THE CLEVELAND ELECTRIC ILLUMINATING COMPANY

March 21, 1985
PY-CEI/NRR-0220 L

Perry Nuclear Power Plant
Docket Nos. 50-440; 50-441
SER License Condition (5)
Hydrogen Control

List of Changes

Figure 4.4.2-1
Comparison of Igniter Assembly Temperature Response
to PNPP & GGNS CLASIX-3 Temperature Profiles

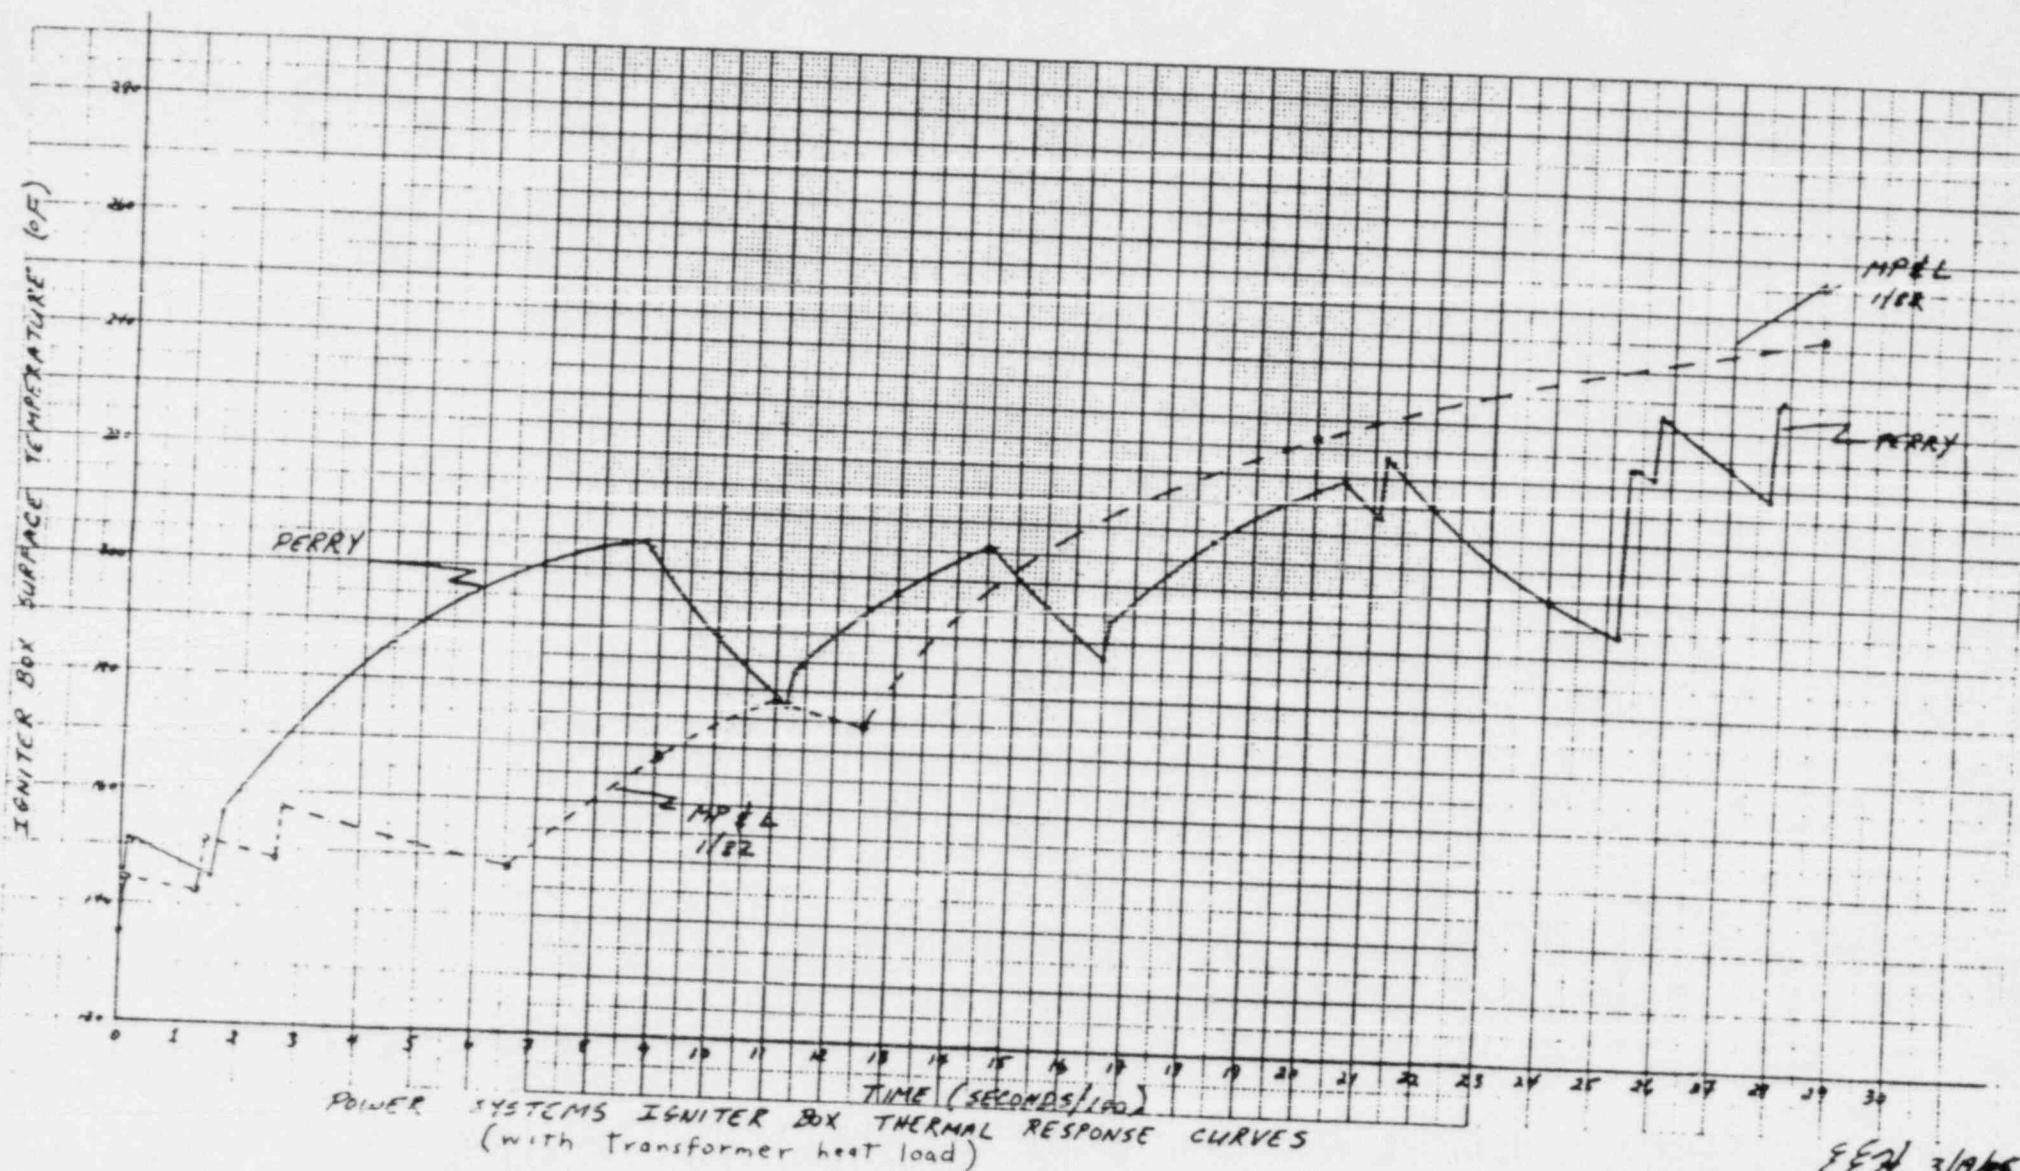
7.	21a through 21d	Section 4.4	Add new section 4.4 including pages 21a thorough 21d
8.	Table 4.4.2-1	Table 4.4.2-1	Add new Table 4.4.2-1
9.	Figure 4.4.2-1	Figure 4.4.2-1	Add new Figure 4.4.2-1

A comparison of the igniter assembly temperature response to the PNPP and GGNS CLASIX-3 temperature profiles is shown in Figure 4.4.2-1. The response is based upon the GGNS and PNPP SORV base case wetwell temperature profiles which are shown in Figure 5.5-2 (also Figure 2 of MP&L letter AECM-82/26) and Figure 4 of Appendix A for GGNS and PNPP respectively.

The igniter assembly response is as expected. During the initial part of the transient the PNPP temperature response is higher due to the higher initial peak burn temperature and the greater number of burns for about the first 700 seconds of burn time. However, later in the transient, the GGNS temperature response is higher due to substantially more burns with less time between burns. This effect is dominant and much more significant than the higher PNPP peak burn temperatures at the end of the transient which result from coincident wetwell and containment burning.

Figure 5.4.3-2
 PNPP DRYWELL PURGE/VACUUM BREAKER INLET LINES

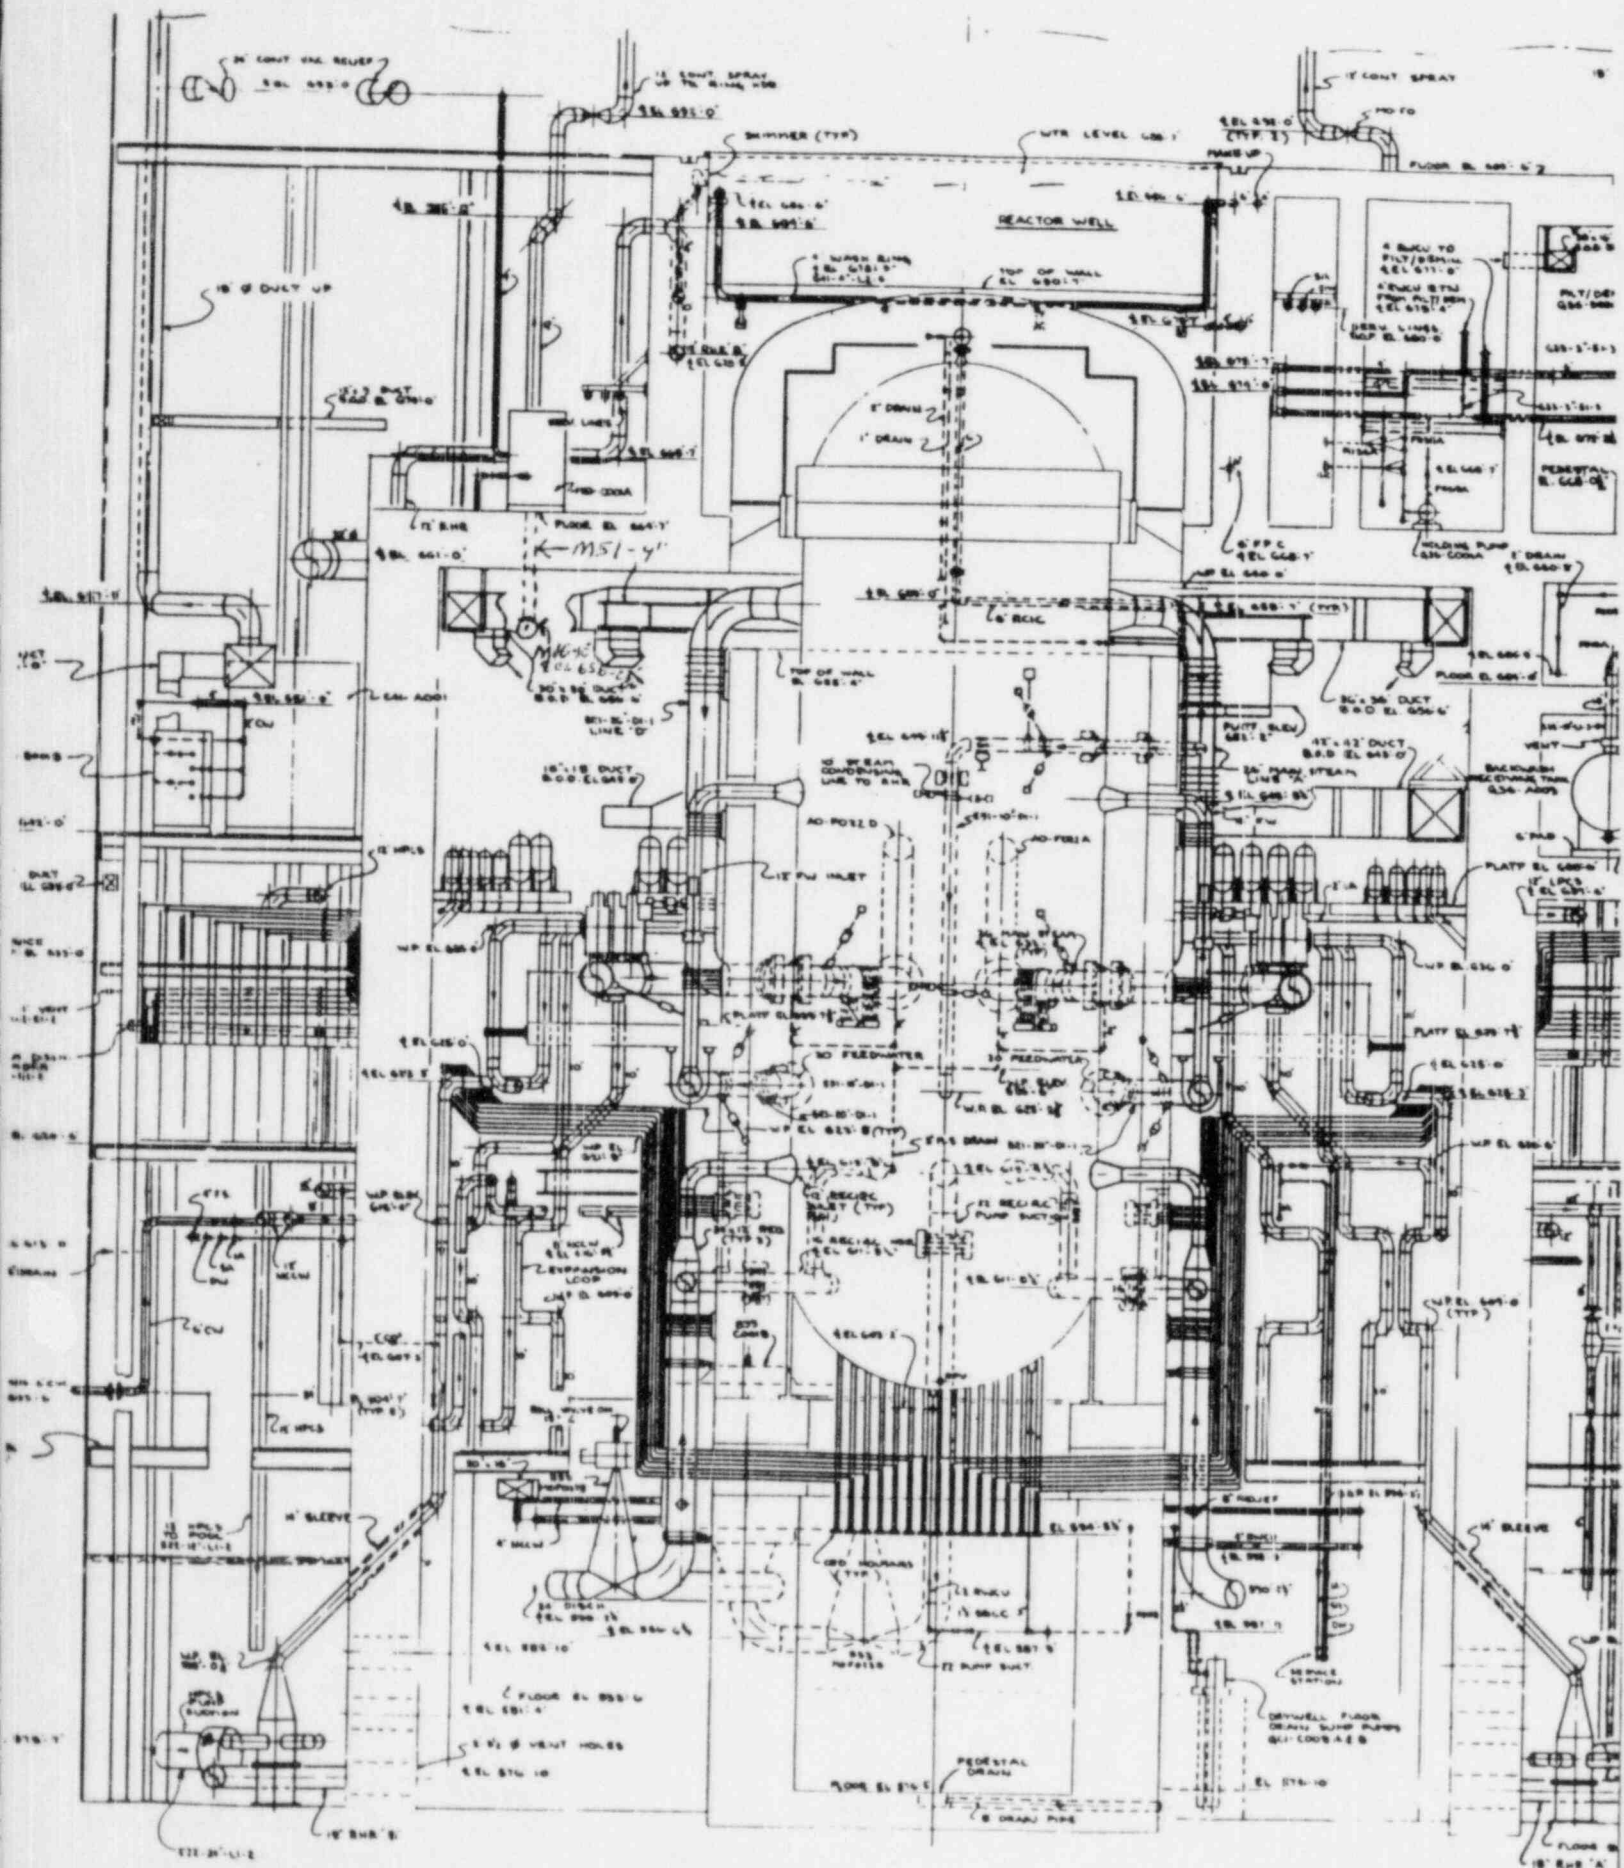
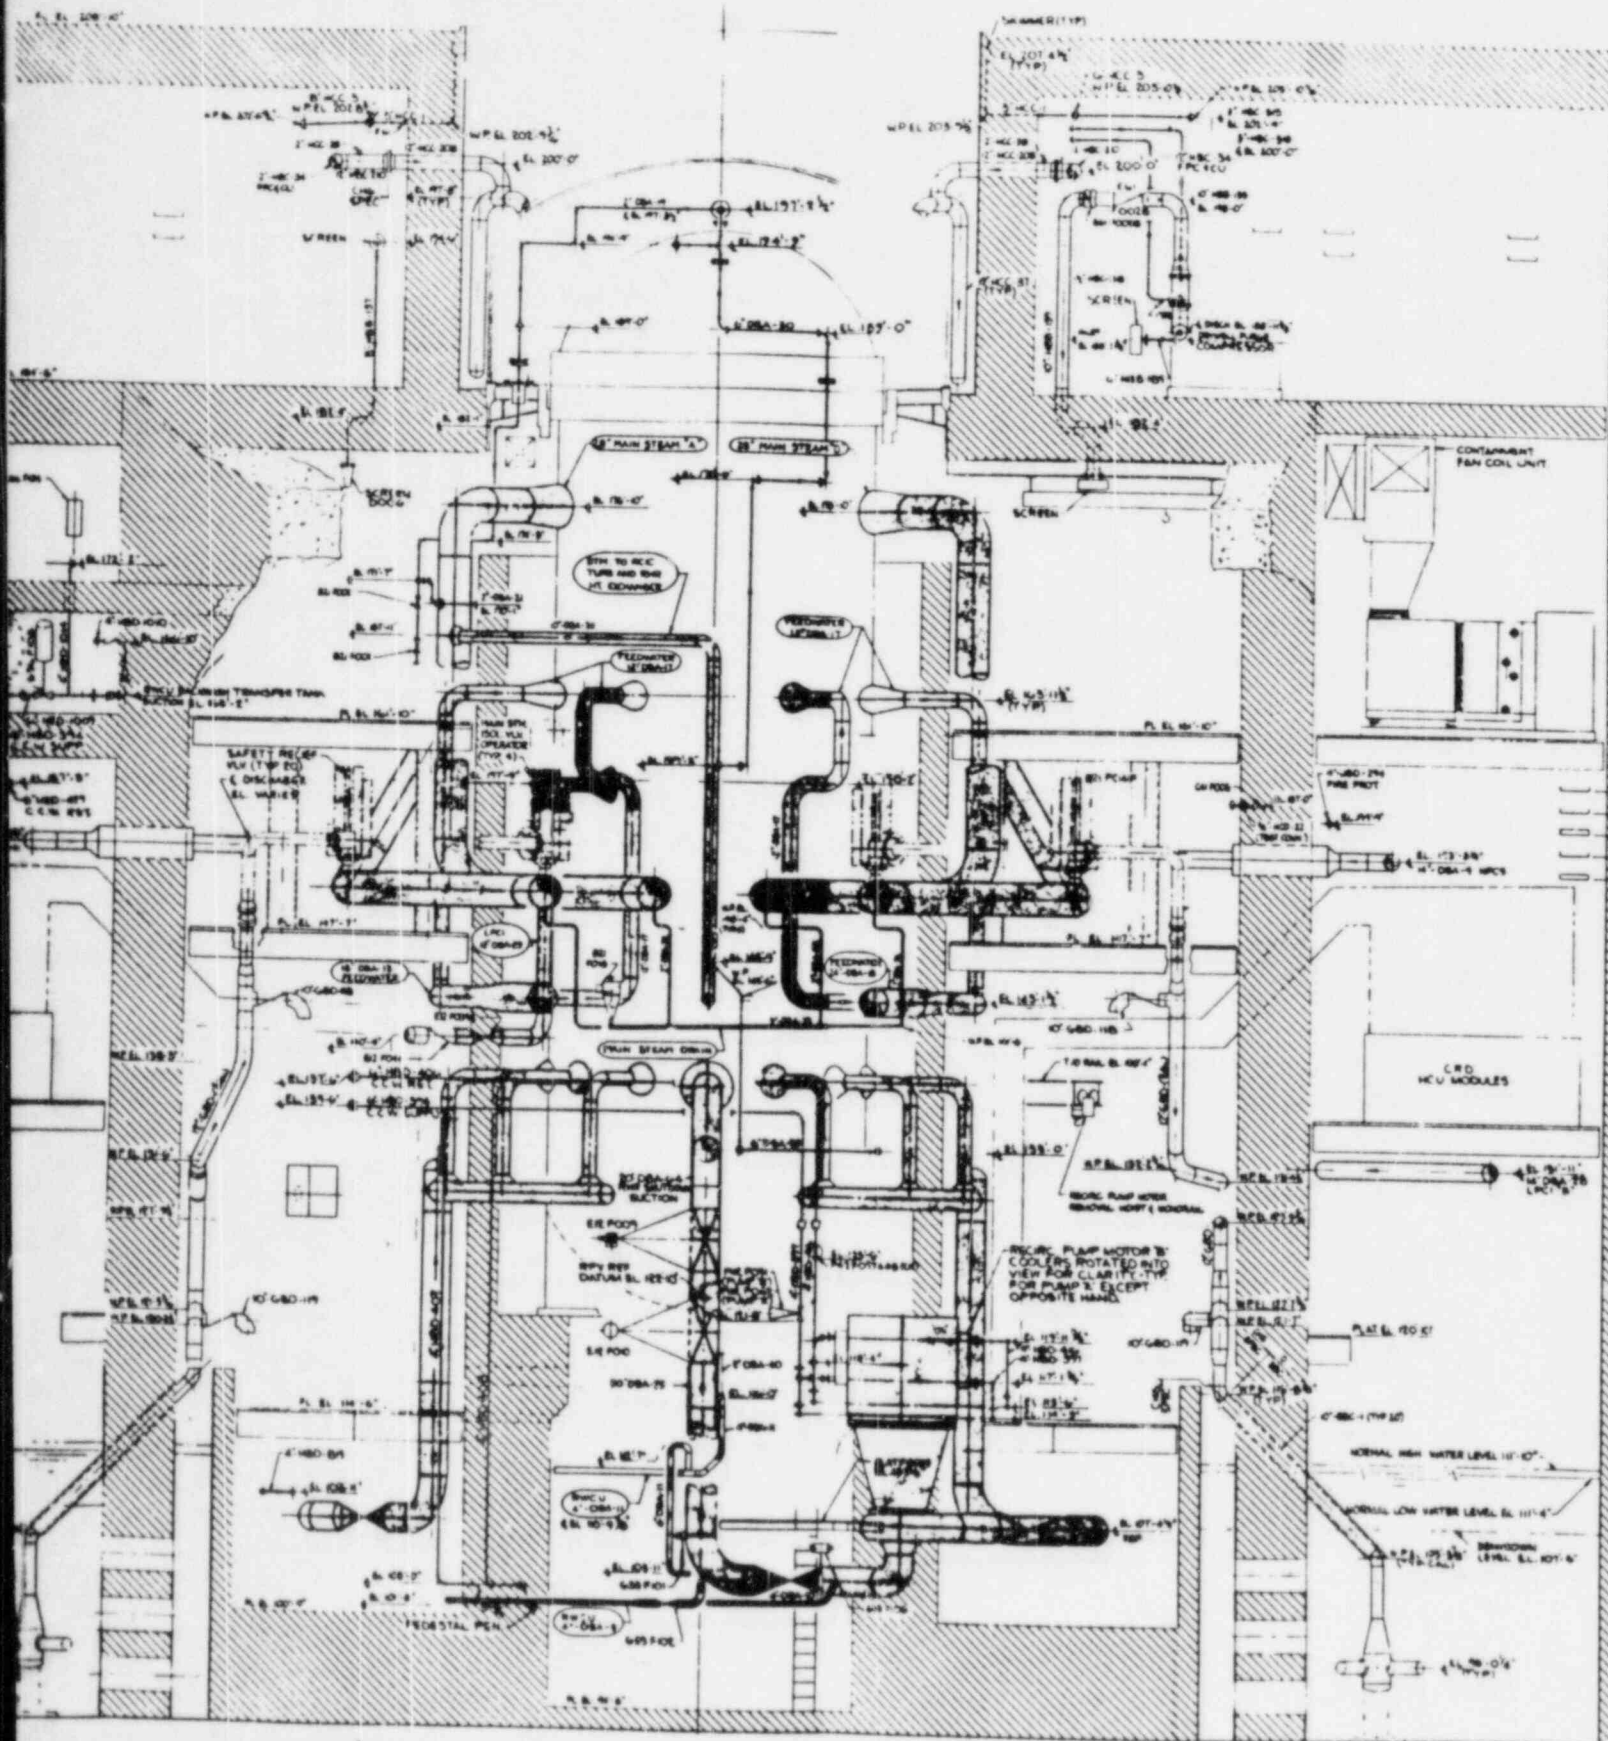
10.	Page 27	5-4.3	Replace page 27 with revised page 27
11.	Page 27a	5-4.3	Add page 27a
12.	Figures 5.4.3-1 through 3	Figures 5.4.3-1 through 3	Add new Figure 5.4.3-1 through 3

- e. The PNPP drywell purge compressor and vacuum breaker discharge lines penetrate the drywell from the side of the drywell at the top of the cylinder instead of through the flat, horizontal drywell top slab as in GGNS. Figures 5.4.3-1 and 2 and Figure 5.4.3-3 show typical drywell purge and vacuum breaker inlet line arrangements for PNPP and GGNS respectively.

FIGURE 18

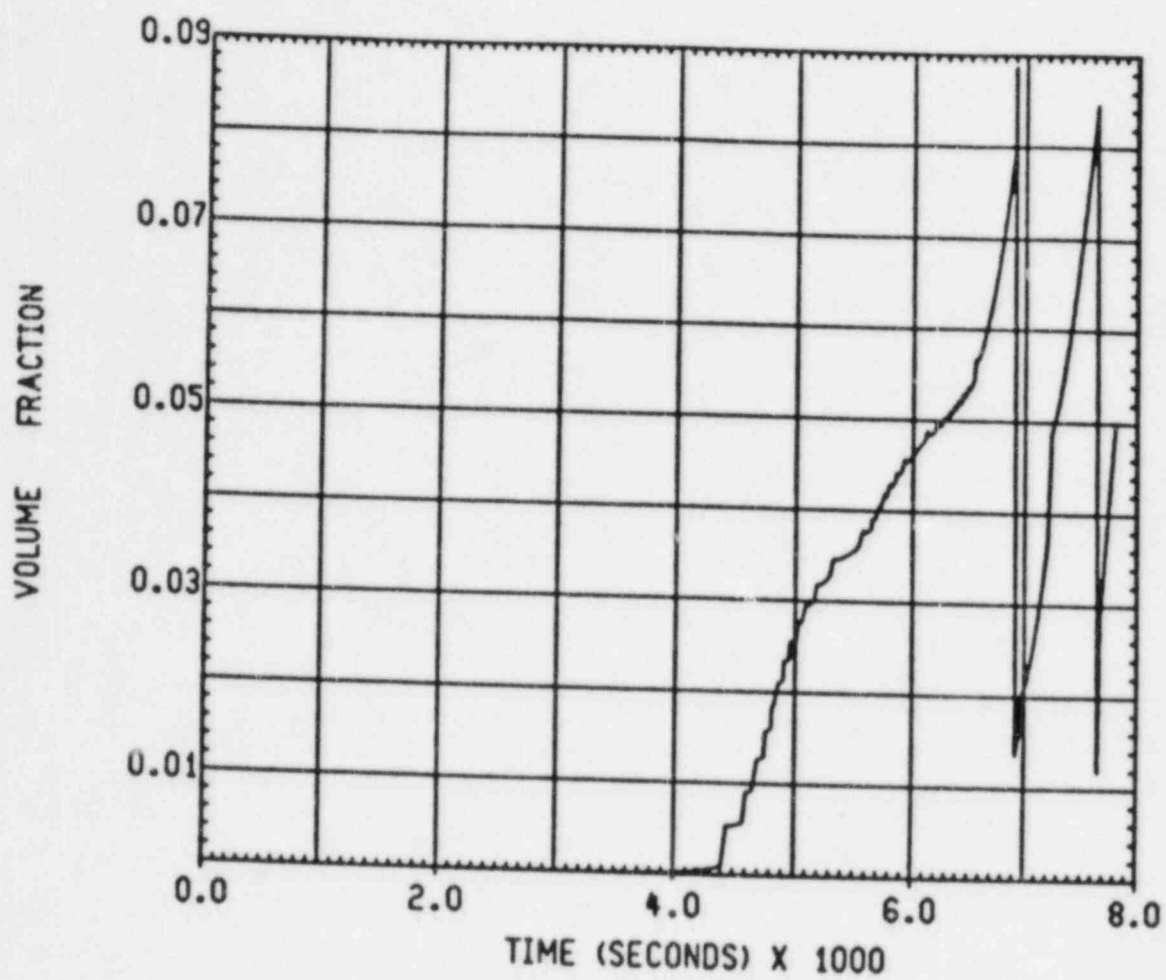
13.	Table 5.6-1 & 5.6-2	Table 5.6-1 & 5.6-2	Add revised Tables 5.6-1 & 5.6-2
14.	Appendix A, Page 15	Table 8	Add page 15, Table 8
15.	Appendix A, Figure 18	Figure 18	Replace Figure 18
